**Re: Item No. 11.3**

## PROJECT DATA

- PROJECT MODIFICATIONS - (from PIM)

- BEFORE / AFTER -

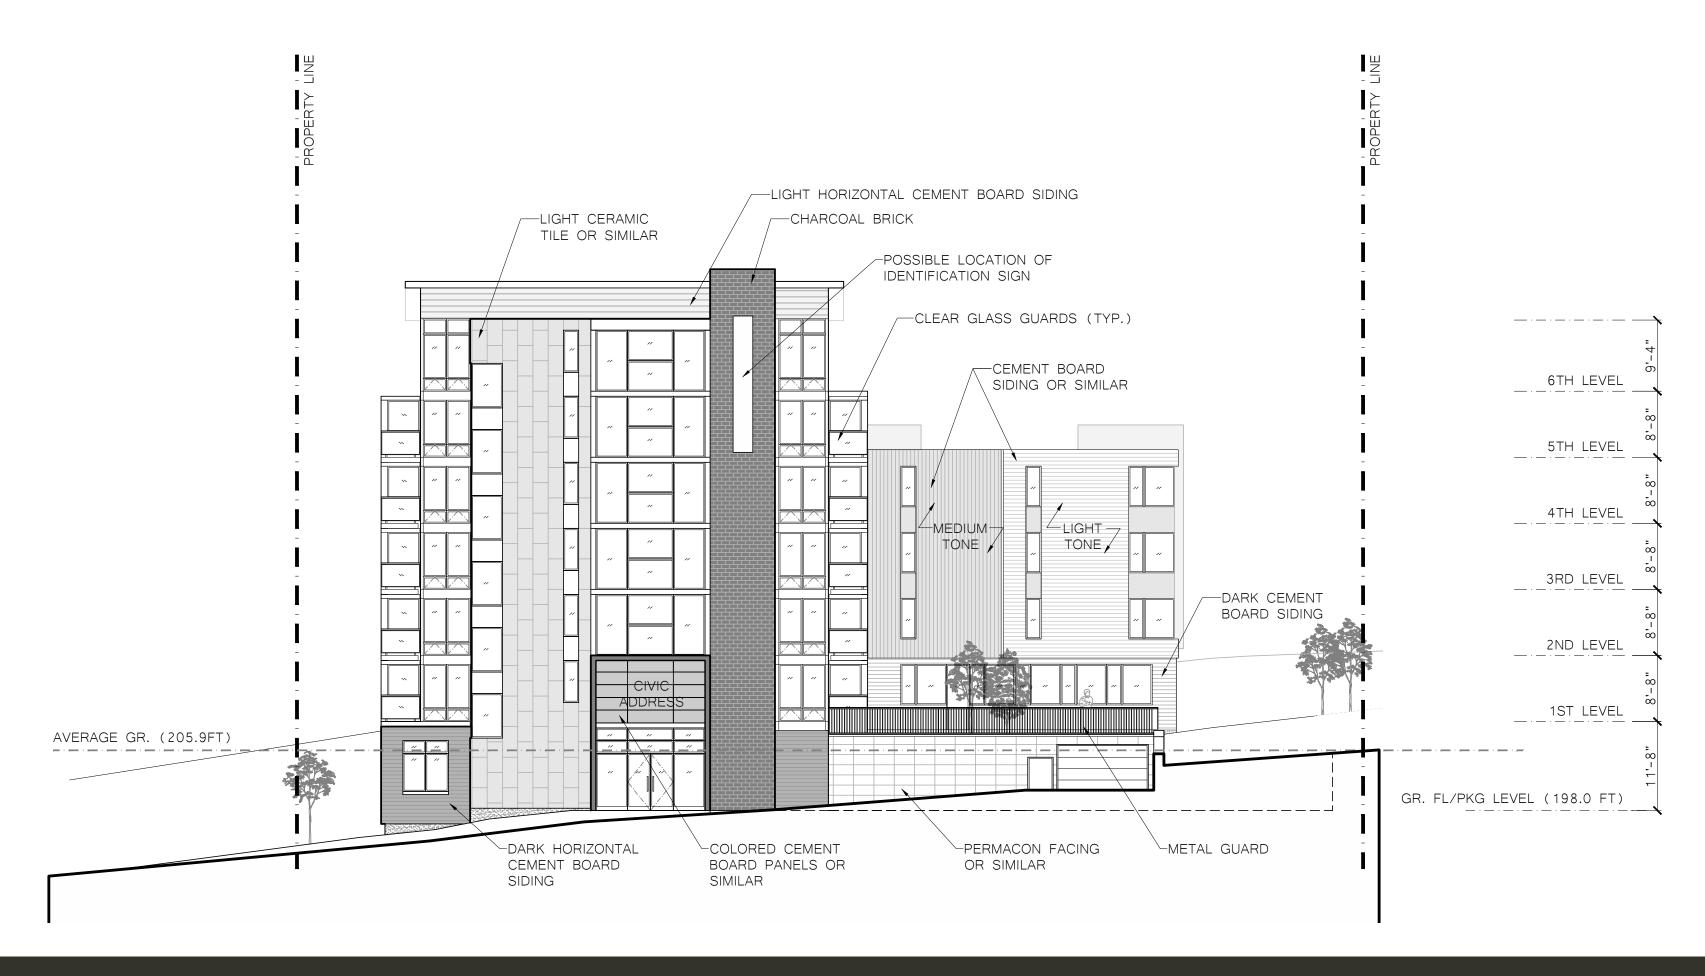
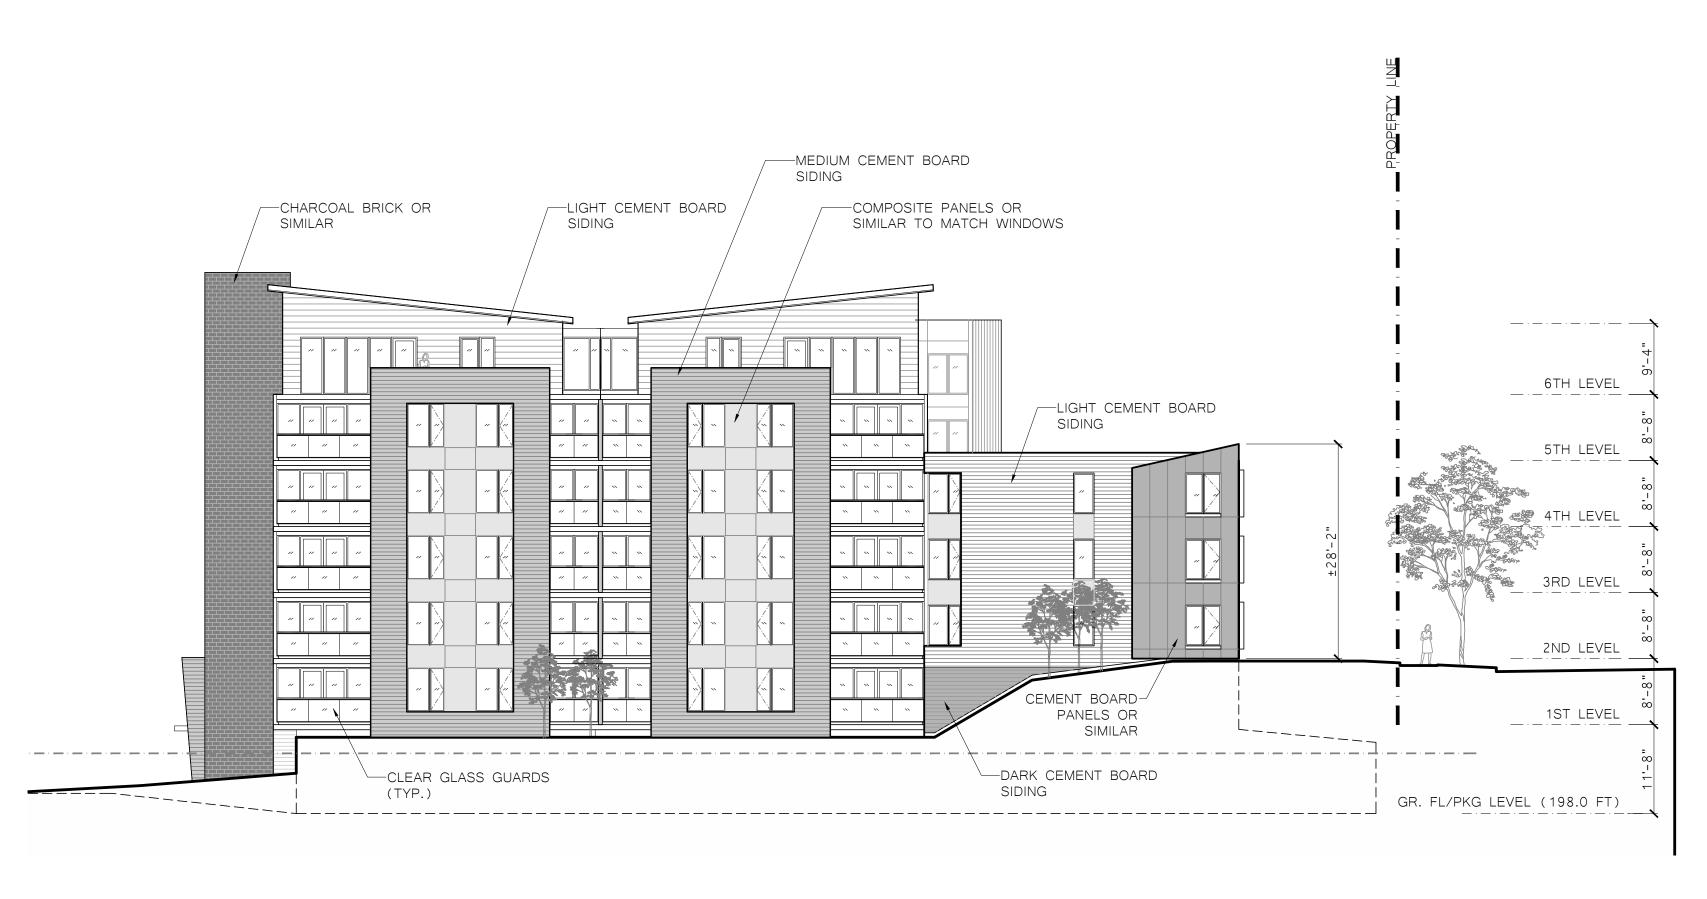
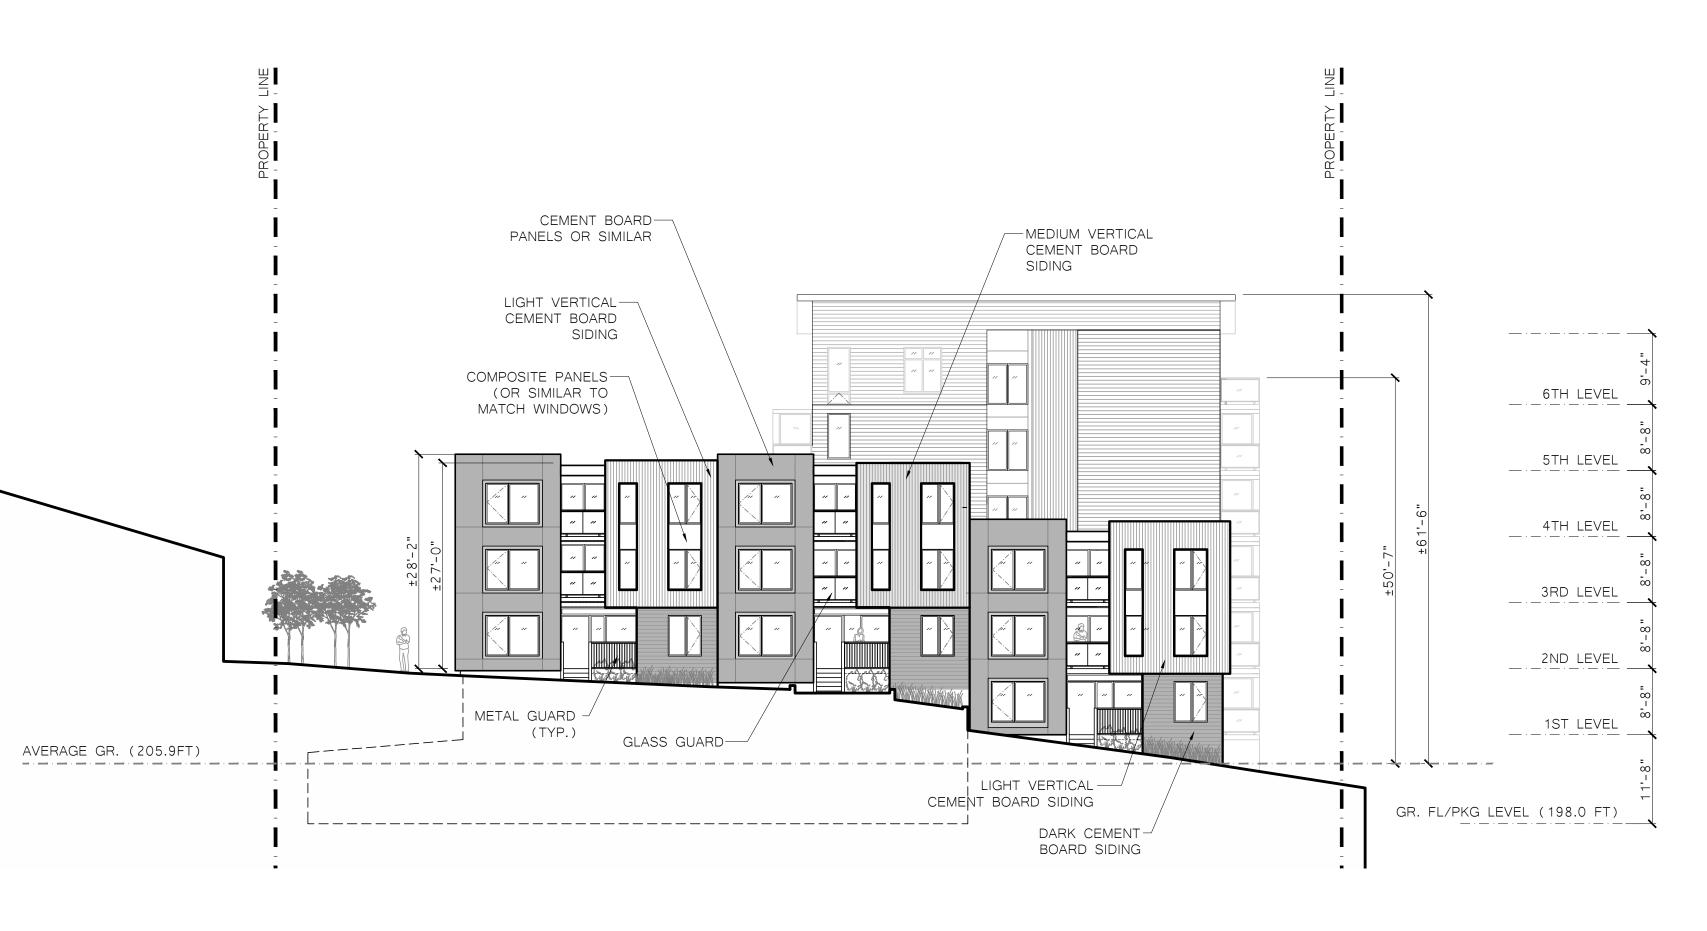
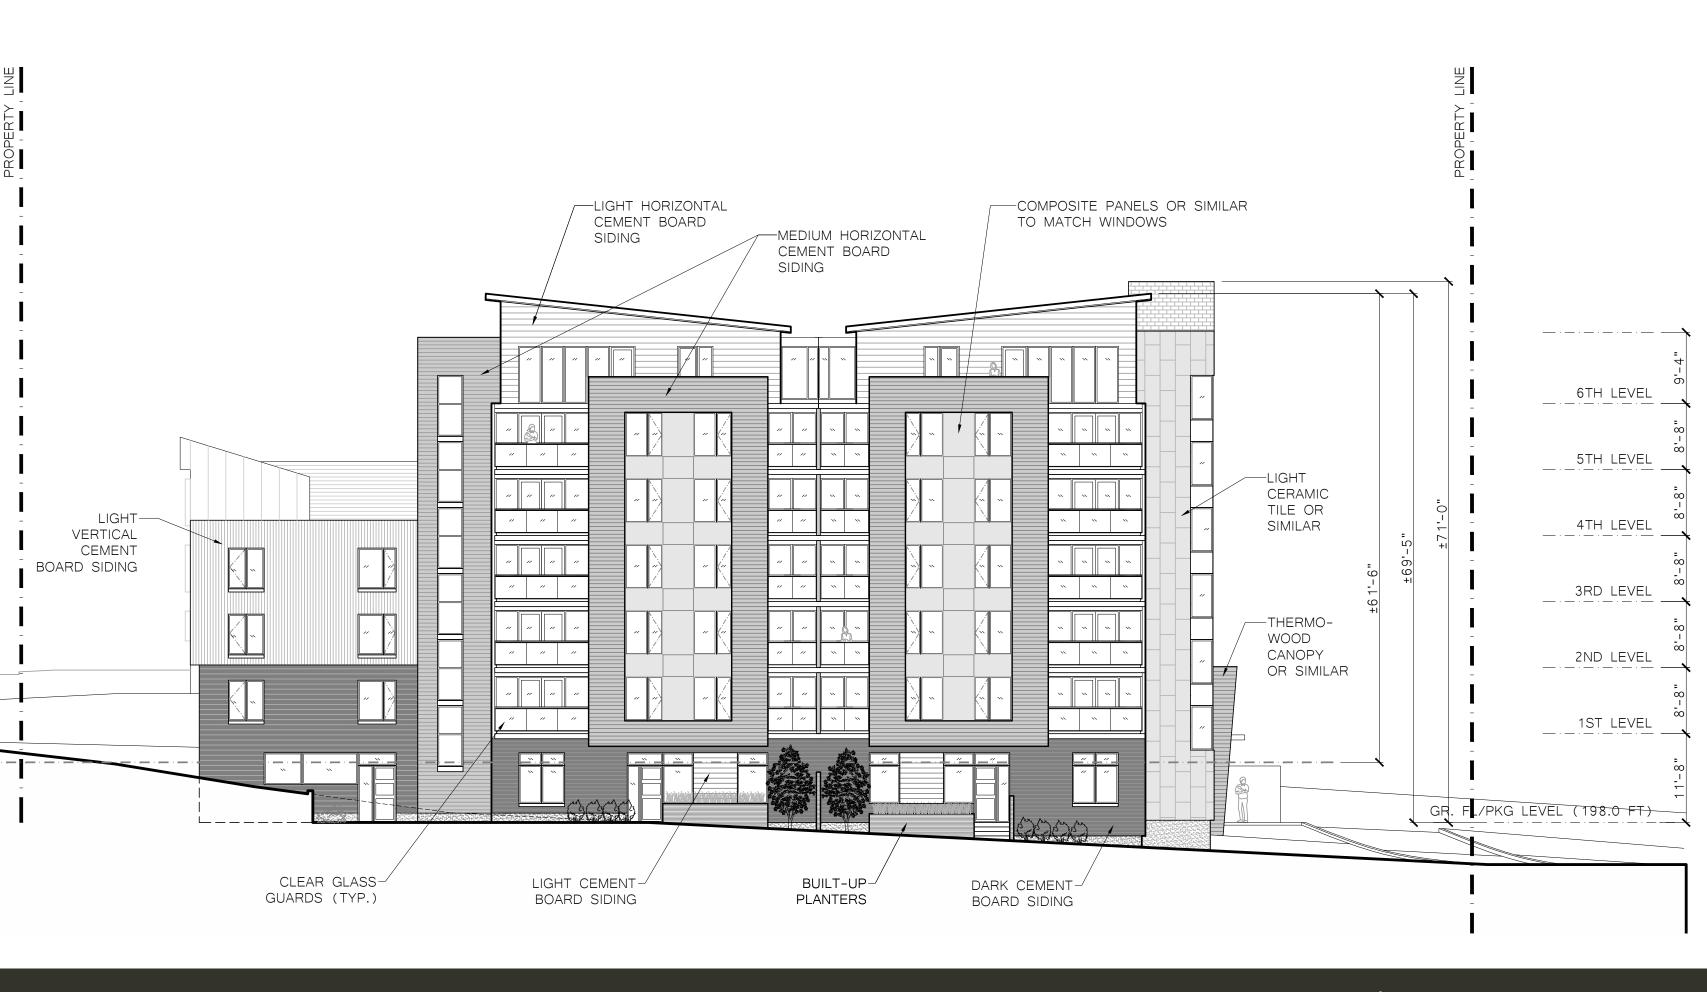
- tree/vegetative buffering to adjacent single family dwellings
- integrated design at entries
- articulated and varied plant species, paving and builtin planters.

- simplified volumes and coordinated building materials
- increased depth and volumetric articulation facing Normandy Drive
- recessed balconies along Normandy Drive
- separate entries with integrated landscaping for all units at grade.
- reduction of balcony sizes
- clear glass balcony guards

- increased setback to interior lot line along Normandy Drive
- reduction of 1 storey
- adjusted building siting in relation to 30 foot change in grade across site
- taller portion of building stepped down with grade change.
- overall 2 storey reduction relative to Normandy Dr. / High St.
